**Proposed P&A NOI
State of NM Orphan Well Program
Cato San Andres Unit #16**

State of NM Orphan Well Project: Cano Petro of NM				PROPOSED
Author:	Abby @ JMR			
Well Name	Cato San Andres Unit	Well No.	#16	
Field/Pool	Cato; San Andres	API #:	30-005-20067	
County	Chaves	Location:	660 FNL & 660 FEL	
State	NM		Sec 9, T08S, R30E	
Spud Date	5/6/1967	GL:

**Cato San Andres Unit 16
BLM
March 25, 2025
Conditions of Approval**

Action 453073

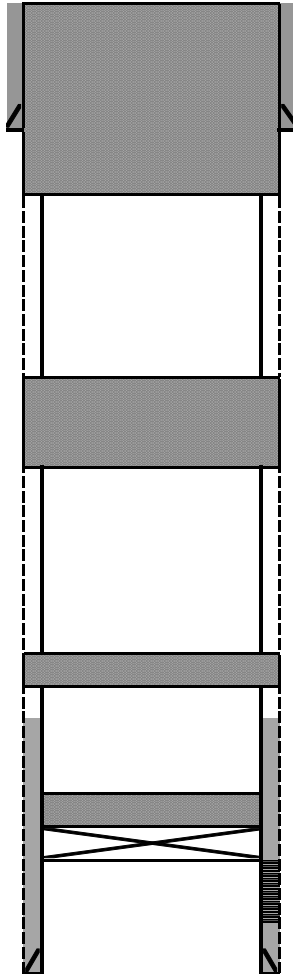
1. Operator shall place CIBP at 3,138' (50'-100' above top most perf) and place a minimum of 50 sx of Class C cement on top to isolate the top of the San Andres Formation. WOC and TAG a minimum of 2,415'.

2. Operator shall place a balanced Class C plug from 2,593' to 2,468' to seal the San Andres Formation.
3. Operator shall perf at 2,178' and squeeze Class C cement to 2,015' seal the Grayburg and Queen Formations. WOC and TAG.

4. Operator shall perf at 1,472' and squeeze Class C cement to 1,297' seal the Yates and bottom of the Salt Formations. WOC and TAG.
5. Operator shall perf at 1,119' and squeeze Class C cement to 905' seal the top of Salt and Rustler Formations. WOC and TAG.

6. Operator shall perf at 577' and squeeze class c cement to surface to seal the 8-5/8" casing shoe.
7. Dry hole marker must be below ground.
8. Surface reclamation will need to be completed once the well bore has been plugged. Please contact rflores@blm.gov for additional information.
